15.2.0 SAFETY LIMITS AND LIMITING SAFETY SYSTEM SETTINGS

1. Revised Safety Limits/Transition Core Elimination

1.1 Proposed Change

Figure 15.2.1-1
REACTOR CORE SAFETY LIMITS
POINT BEACH UNITS 1 AND 2

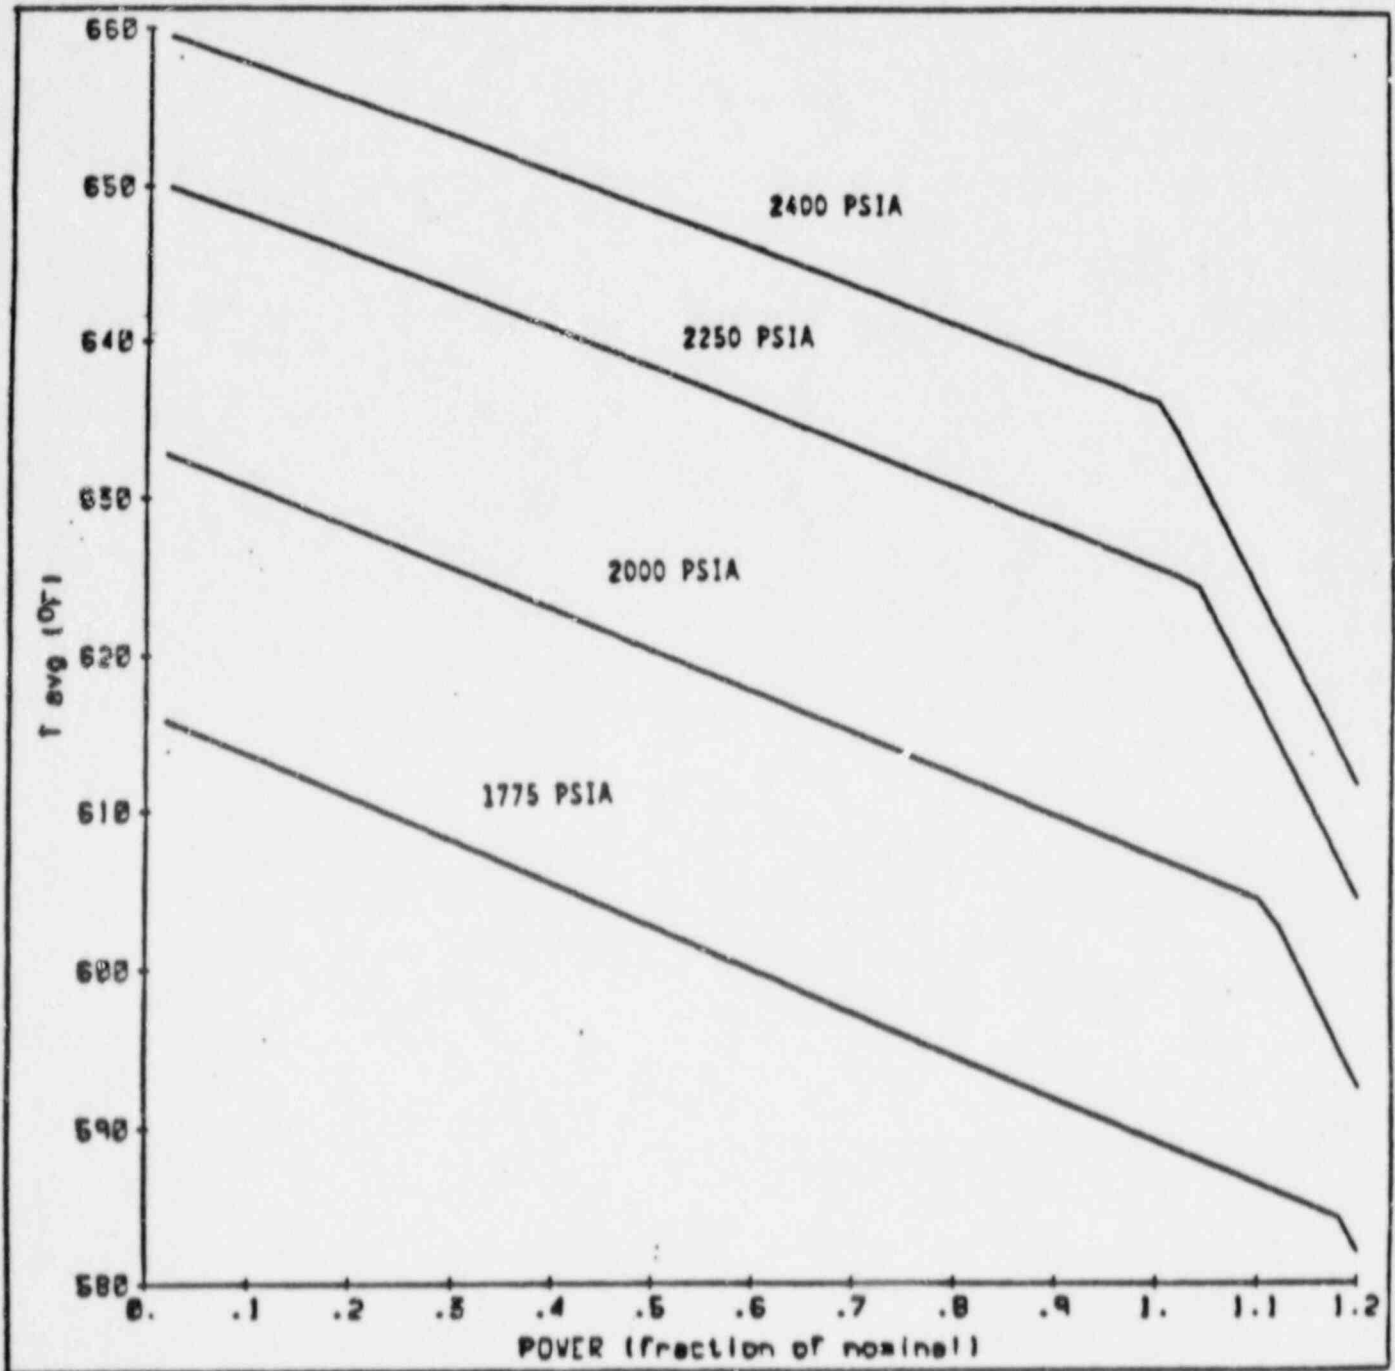
The first change involve replacement of the two sets of Transition Core DNB Safety Limits (one for optimized fuel assemblies and one for transition cores) with a single revised Reactor Core Safety Limits figure. The revised Safety Limits reflect the proposed upgraded core features including the increase in enthalpy rise hot channel factor (F-delta-H) from 1.58 to 1.70, the increase in core bypass flow due to the elimination of the thimble plugging devices, and certain minor upgrades to the fuel design. Consideration of a transition core has been eliminated, since the transition from standard fuel assemblies (STD) to optimized fuel assemblies (OFA) will be completed for both units by April 1989. The changes in TS 15.2.1.1, the basis of TS 15.2.1.1, and the basis of TS 15.2.3 eliminate the reference to the Transition Core Safety Limits, and eliminate the definition of a transition core. Figures 15.2.1-1 and 15.2.1-2 are replaced with the revised Figure 15.2.1-1. Finally, the change in TS 15.5.3.A.2 and the deletion of the current TS 15.5.3.A.3, TS 15.5.3.A.4, and TS 15.5.3.A.5 revise the description of a reactor core to reflect the elimination of transition core considerations.

The revised Safety Limits were developed in the safety analyses to ensure acceptable DNB results for the higher F-delta-H limit and the higher core bypass flow due to thimble plugging device elimination. The limits are used to determine the acceptability of the consequences of certain design-basis events and as such have no effect on the probability of those events

The design-basis accidents for which the core Safety Limits are used (Uncontrolled RCCA Withdrawal at Power, Reduction in Feedwater Enthalpy Incident, Excessive Load Increase Incident, and Loss of External Electrical Load) were reanalyzed assuming the revised Reactor Core DNB Safety Limits. The results show that the minimum DNBR value for each event is greater than the Safety Analysis Limit value, derived through the use of the Revised Thermal Design Procedure (RTDP) as described in WCAP-11397, "Revised Thermal Design Procedure." Through the RTDP, a design limit DNBR value is calculated. This is then increased to provide margin to the design limit; the increased value is the safety analysis limit value. Since the analysis of these accidents show that the calculated DNBR is greater than the safety analysis limit value, there will be no significant increase in the consequences of an accident previously evaluated.

FIGURE 15.3.10-1

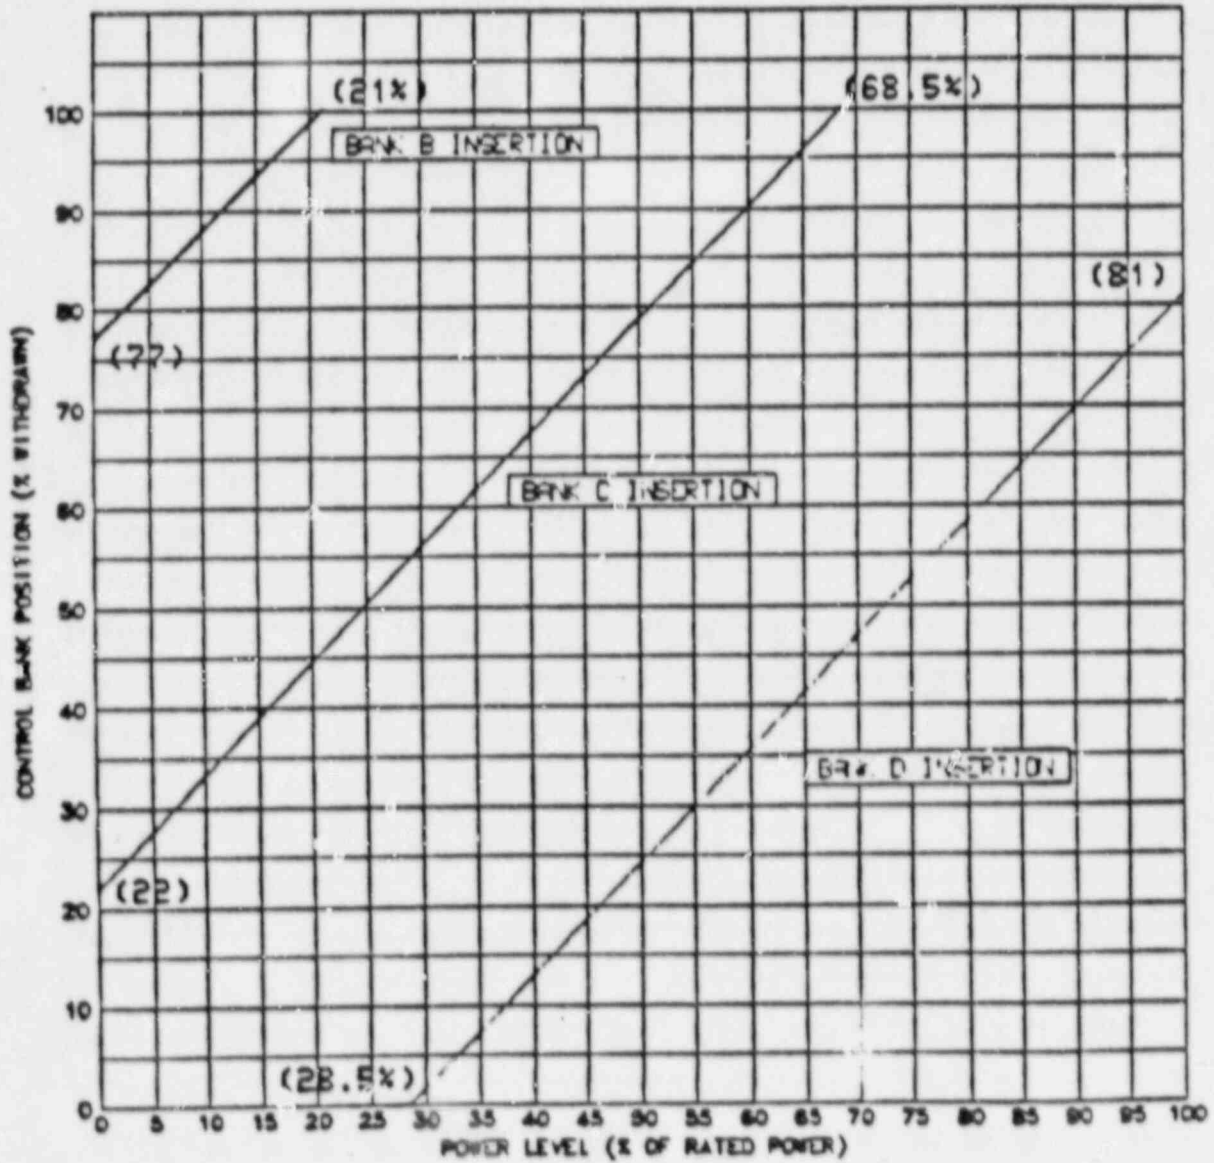
This change involves a revision to the Control Bank Insertion Limits. Figure 15.3.10-1 of TS 15.3.10 is revised to obtain a wider delta-I band and to ensure that the delta-I band will be conservative for future fuel cycles using upgraded core features. The revised insertion limits require a smaller insertion at any given power level. This increases the allowable power level at the top of the core, which results in a larger allowable positive axial offset. The delta-I band is therefore wider and will bound future cycles. This evaluation assumes acceptable results from the Upper Plenum Injection (UPI) Large-Break LOCA reanalysis project scheduled for completion in October 1988.

The Control Bank Insertion Limits are revised to obtain a revised operating delta-I band, which are input to the safety analyses. The limits are used to provide for achieving hot shutdown by reactor trip at any time. Additionally, they help determine the consequences of certain design-basis events. The Control Bank Insertion Limits have no effect on the probability of those events occurring. There will therefore be no significant increase in the probability of occurrence of any of the accidents previously analyzed using these limits.

The revised Control Bank Insertion Limits can impact the non-LOCA safety analyses in the following areas: shutdown margin, trip reactivity, power distribution limits, ejected and dropped rod worths, post-ejected rod peaking factors, and differential rod worths. The revised limits were encompassed in the nuclear design calculations and in the safety analyses. The results demonstrate that the acceptance criteria for each event were met. The small-break LOCA analysis results demonstrate that the Emergency Core Cooling System (ECCS) satisfies the acceptance criteria of 10 CFR 50.46. Since the analyses of these accidents show that the acceptance criteria are met, there will be no significant increase in the consequences of an accident previously evaluated. This assumes acceptable results from the UPI project.

FIGURE 15.3.10-3

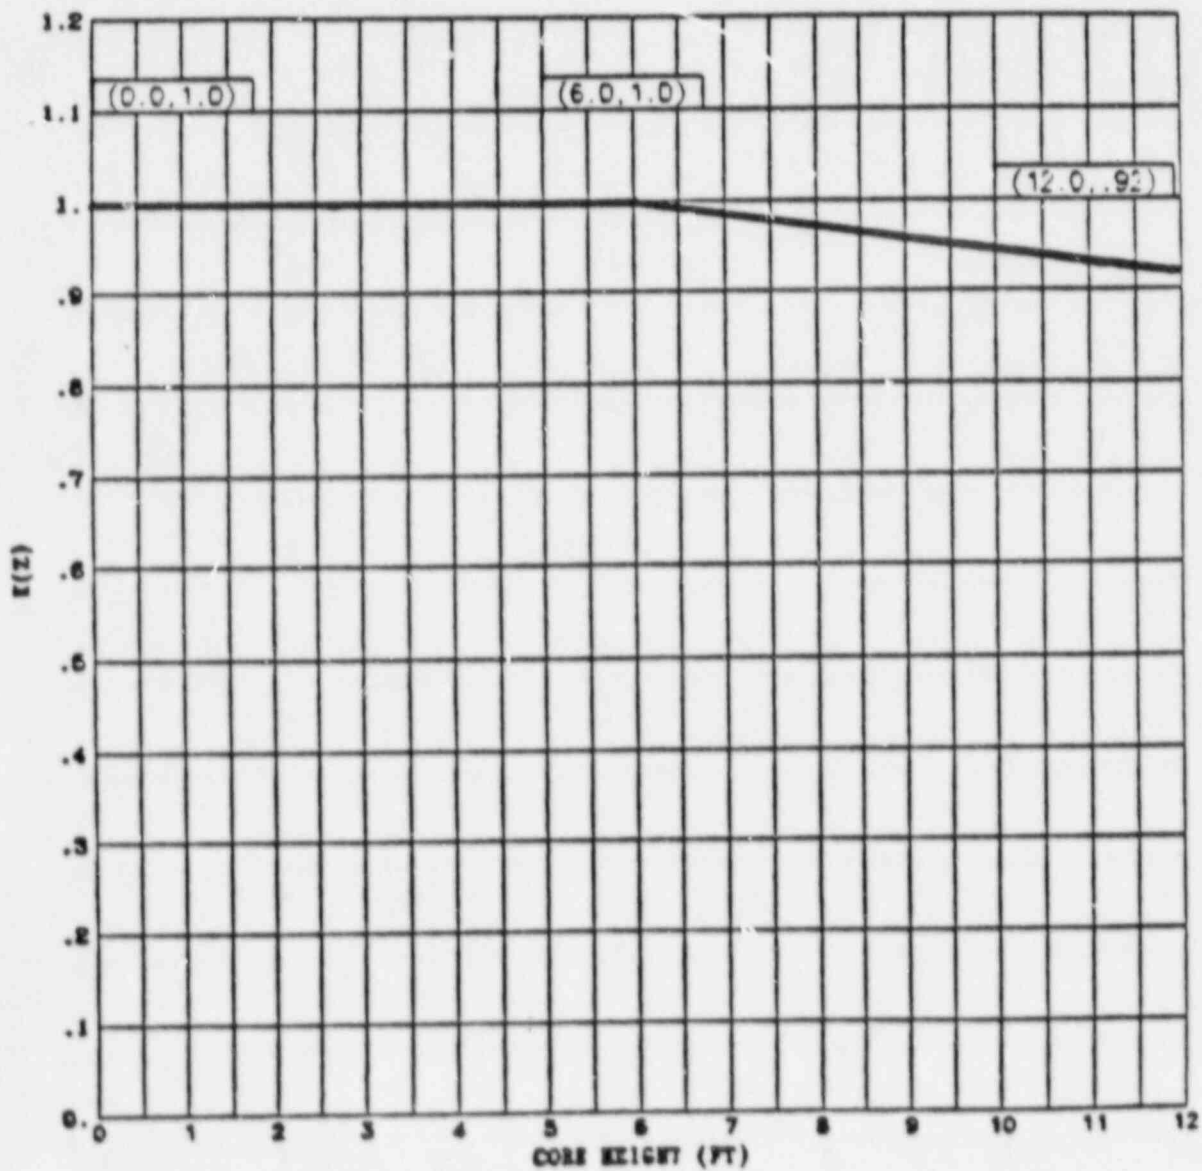
This change involves a revision to the Hot Channel Factor Normalized Axial Operating Envelope ($K(z)$ curve), which is presented in Figure 15.3.10-3 of TS 15.3.10. $K(z)$ is used as a multiplier in the axial height dependent equation for $F_0(z)$ in TS 15.3.10.B.1.a. The third line segment of this curve is eliminated to increase the flexibility of the reload core design and operation by allowing operation at a higher power level at the top of the core. The remaining two line segments of the $K(z)$ curve remain unchanged.

Since the $K(z)$ curve is used in the determination of the axial height dependent F_0 limit, its effects are implicit to the discussion of the F_0 limit in significant hazards evaluation number 6. The conclusions drawn there from the analysis of the F_0 limit are equally applicable to the revised $K(z)$ curve. Therefore, there will be no significant increase in the consequences of an accident previously evaluated.

FIGURE 15.3.10-4

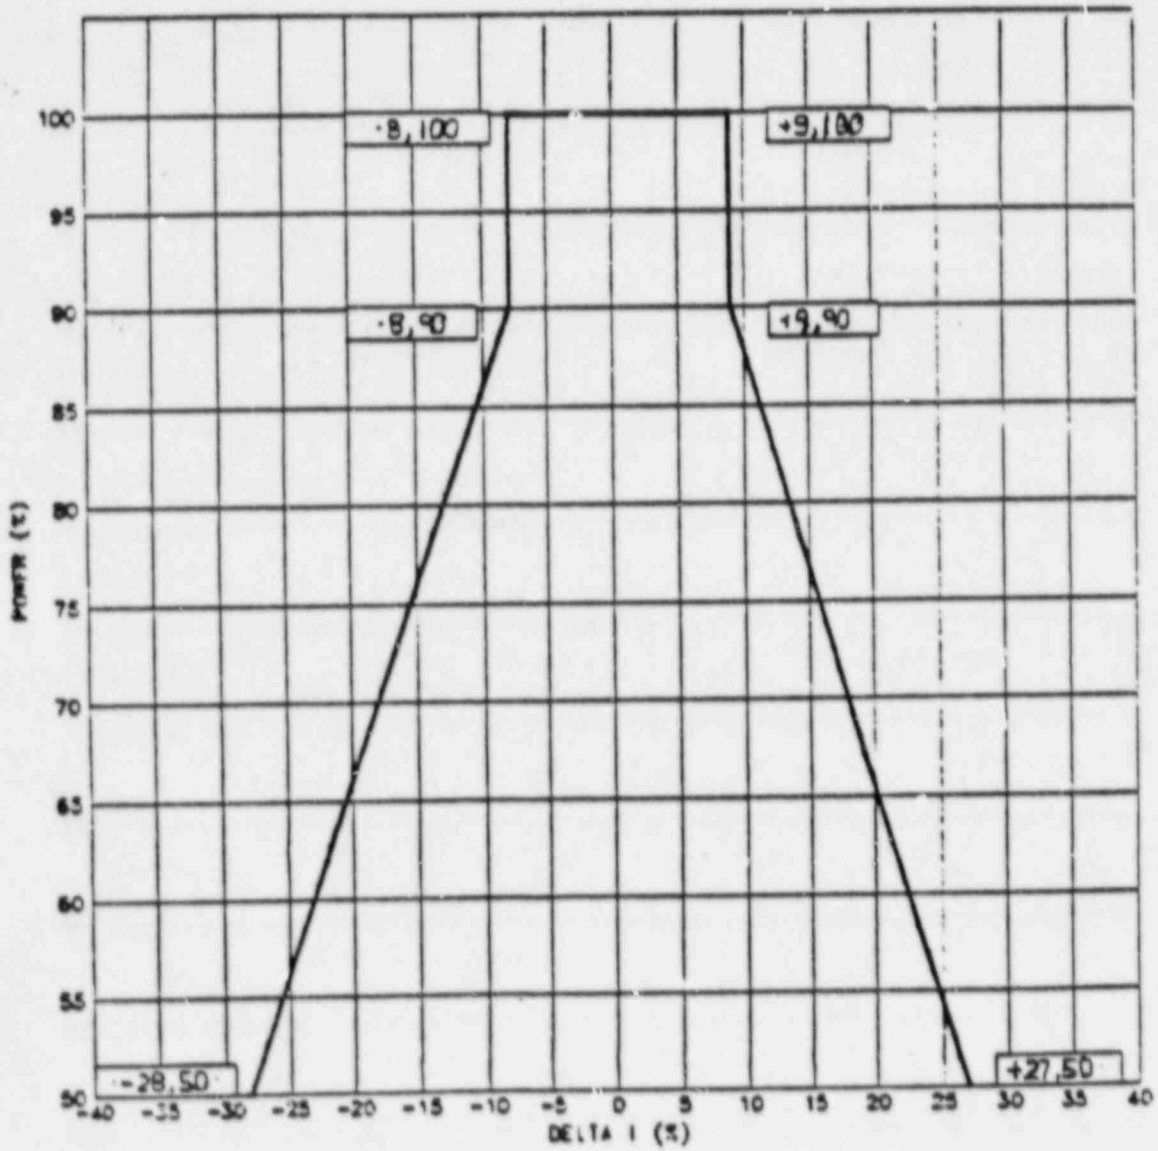
This change involves a revision to the Flux Difference Operating Envelope (delta-I band), Figure 15.3.10-4 of TS 15.3.10. The revision to this figure reflects the use of upgraded core features and the revised Control Bank Insertion Limits. The ways in which these affect the Flux Difference Operating Envelope are explained in Significant Hazards Evaluation section 9.1.

The revised Envelope was developed in the safety analyses to accommodate the upgraded core features. Adherence to the Envelope ensures that the power distribution limits assumed in the safety analyses are met. The Envelope is used to limit the consequences of certain design-basis events and as such has no effect on the probability of those events occurring. There will therefore be no significant increase in the probability of occurrence of any of the accidents previously analyzed using these Safety Limits.

Nuclear design calculations were performed assuming the revised Flux Difference Operating Envelope. Results show that adherence to the Envelope during operation ensures that the power distribution limits assumed in the safety analyses are met. Since those power distribution limits have been shown to be acceptable in Significant Hazards Evaluations 6, 7, 9, and 10, there will be no significant increase in the consequences of an accident previously evaluated.
